PUR-1378
ADDENDUM NO. 2
INVITATION TO BID

THE MARYLAND THEATRE EXPANSION
IN HAGERSOWN, MARYLAND

DATE: Monday, March 26, 2018

A-6.11
2/15/18
BID SET

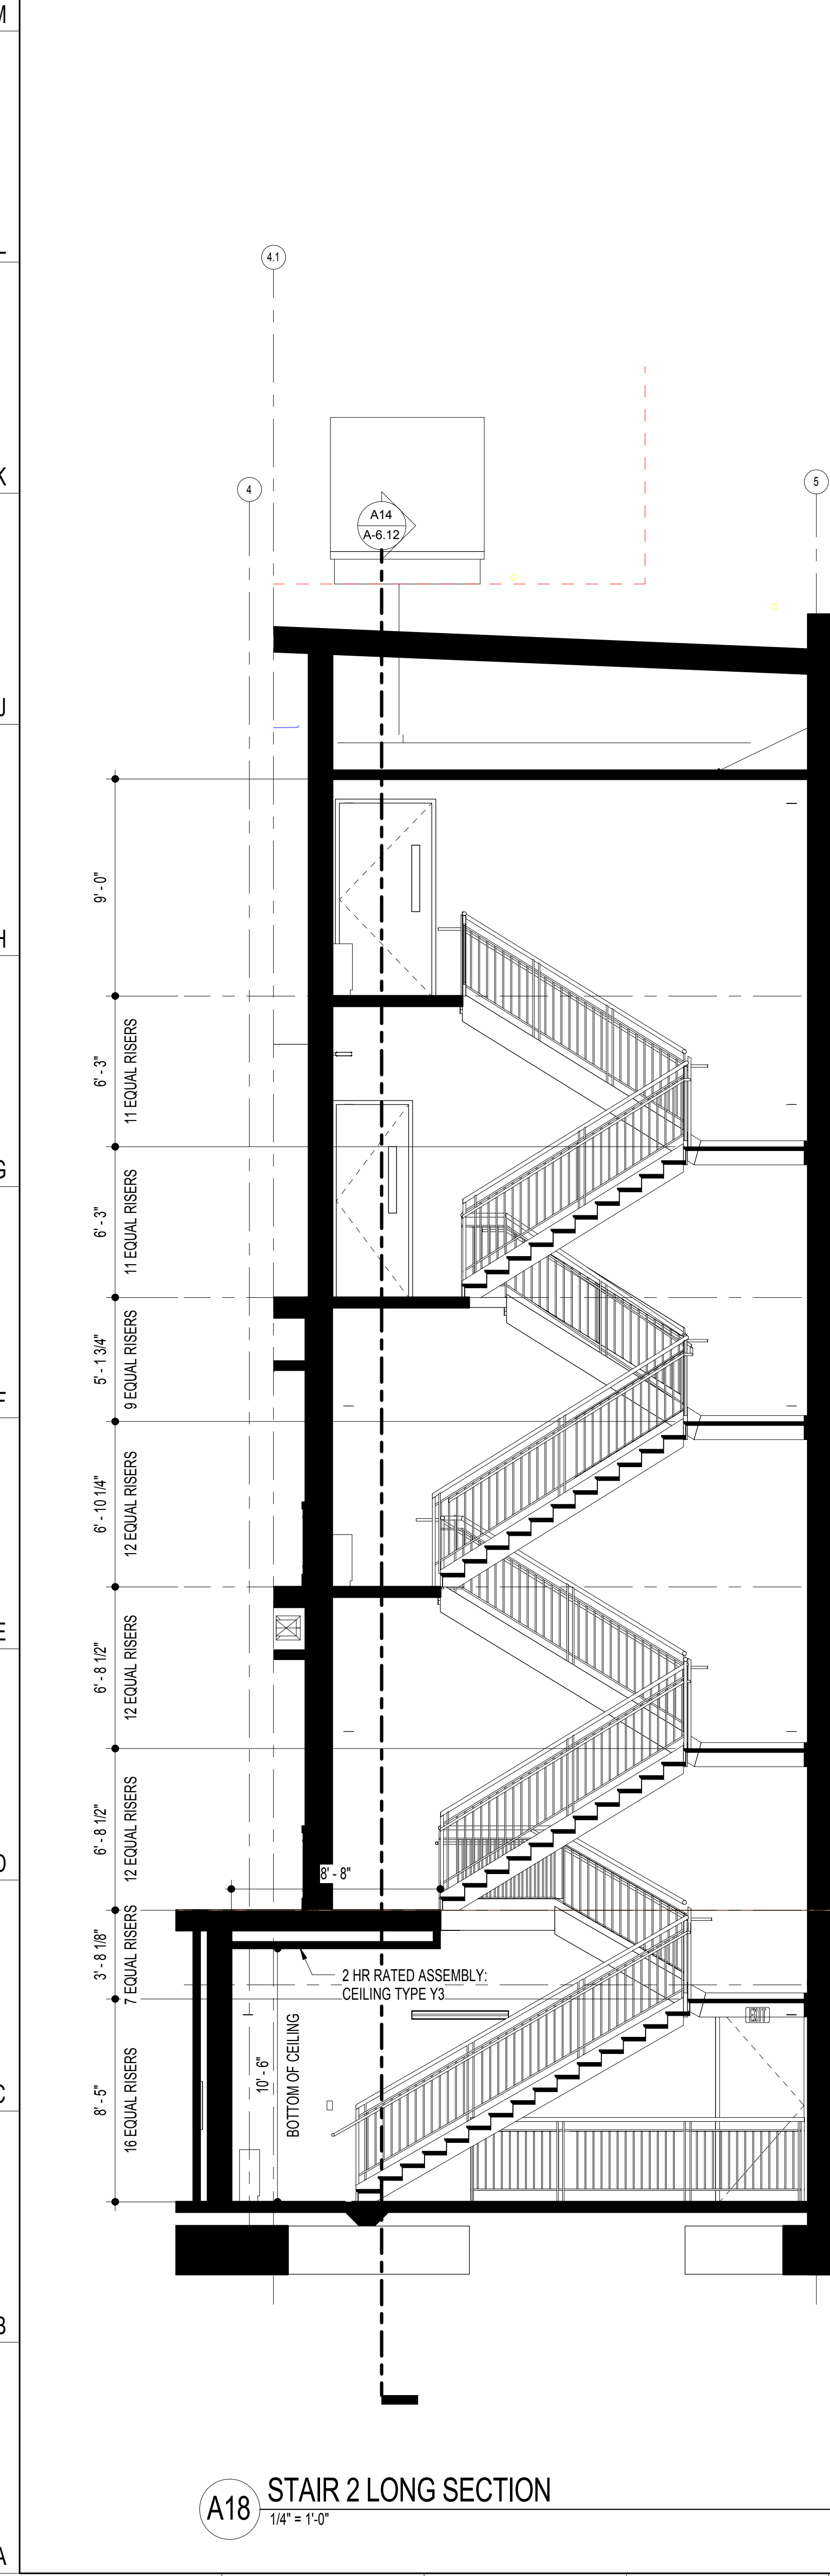
- ITEM NO. 100** SHEET A-6.11– STAIR 1 PLANS AND SECTIONS *(SHEET ATTACHED)*
- REMOVE** Remove 2 risers at Stair 1 to accommodate sidewalk elevations
- REVISE** Center Door EX100
